State of Alaska
Department of Environmental Conservation
Village Safe Water Program

Re: Amendment 2
RFP 22-VSW-UNK-030
Unalakleet Water Distribution Replacement Design
RFP Due Date: January 21, 2022 @ 2:00 PM AST

A2

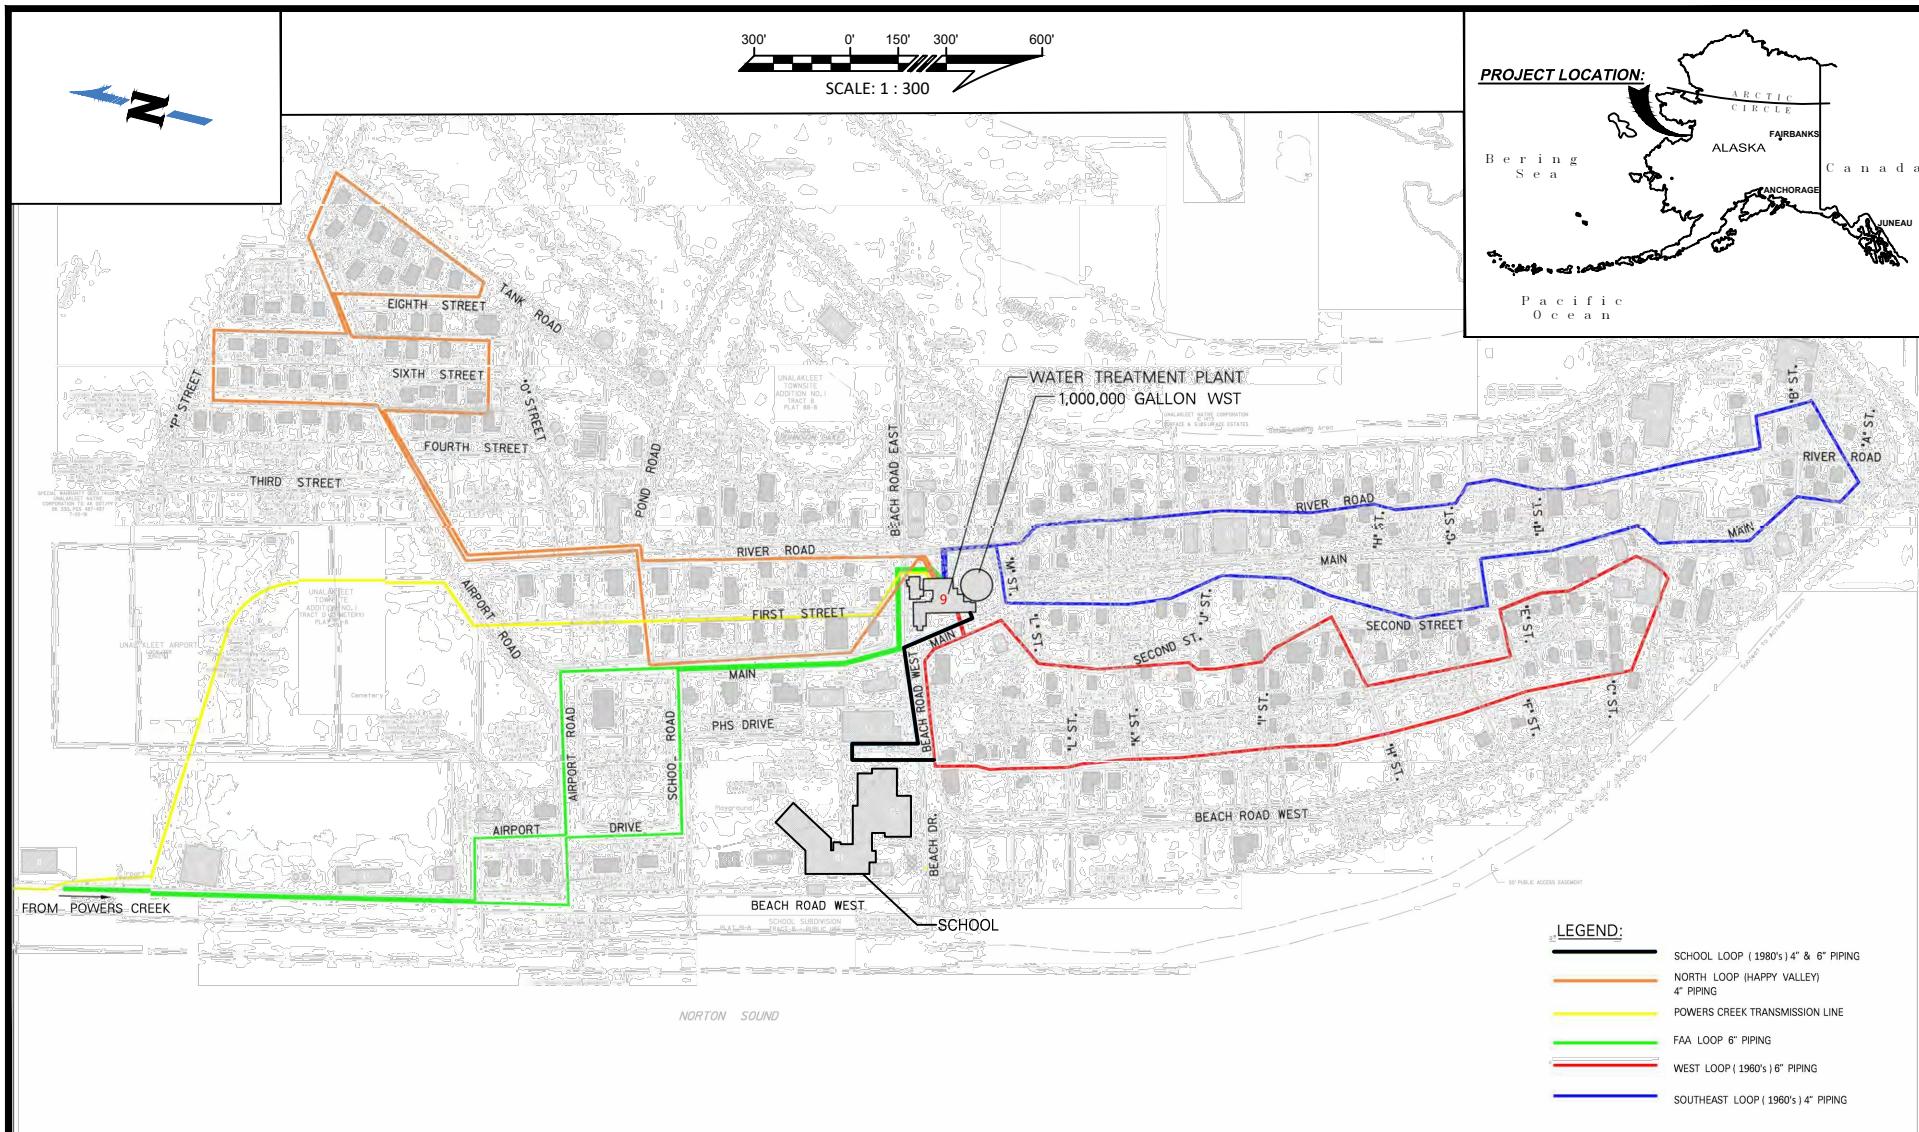
1. Vendor: The four figures Appendix A are blurry – is it possible to obtain legible, higher resolution versions of these figures please?

Department: Please see attached PER, Appendix A.
